Form 3160-3 FORM APPROVED OMB No. 1004-0137 (June 2015) Expires: January 31, 2018 **UNITED STATES** 5. Lease Serial No. DEPARTMENT OF THE INTERIOR NMNM97127 BUREAU OF LAND MANAGEMENT APPLICATION FOR PERMIT TO DRILL OR REENTER 6. If Indian, Allotee or Tribe Name 7. If Unit or CA Agreement, Name and No. **✓** DRILL REENTER 1a. Type of work: 1b. Type of Well: ✓ Oil Well Gas Well Other 8. Lease Name and Well No. 1c. Type of Completion: Hydraulic Fracturing ✓ Single Zone Multiple Zone HONEY BUN 6 FED COM 721H 2. Name of Operator 9. API Well No. 30-015-54242 EOG RESOURCES INCORPORATED 3a. Address 3b. Phone No. (include area code) 10. Field and Pool, or Exploratory WC-025 G-08 S243217P/WOLFCAMP (G 1111 BAGBY SKY LOBBY 2, HOUSTON, TX 77002 (713) 651-7000 4. Location of Well (Report location clearly and in accordance with any State requirements.*) 11. Sec., T. R. M. or Blk. and Survey or Area SEC 6/T26S/R27E/NMP At surface LOT 1 / 308 FNL / 204 FWL / LAT 32.078162 / LONG -104.237355 At proposed prod. zone LOT 4 / 230 FNL / 792 FWL / LAT 32.050476 / LONG -104.235476 12. County or Parish 14. Distance in miles and direction from nearest town or post office* 13 State **EDDY** NM 15. Distance fr

Proposed Wellbore Design A

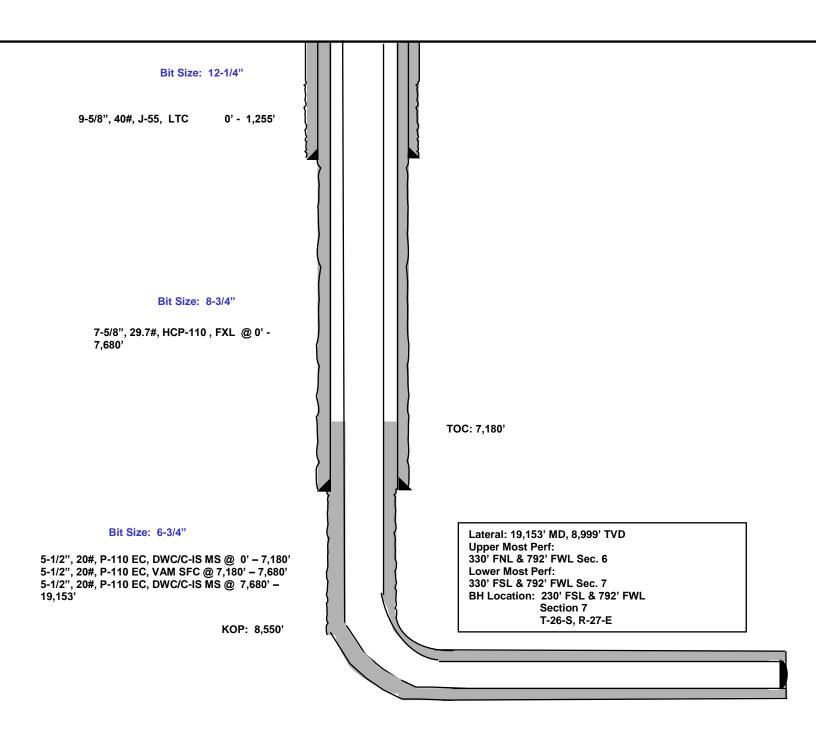
Operator is only approved for Design A. Design B is not to be utilized. If Design B is needed or any other change, please submit a NOI sundry to make the changes.
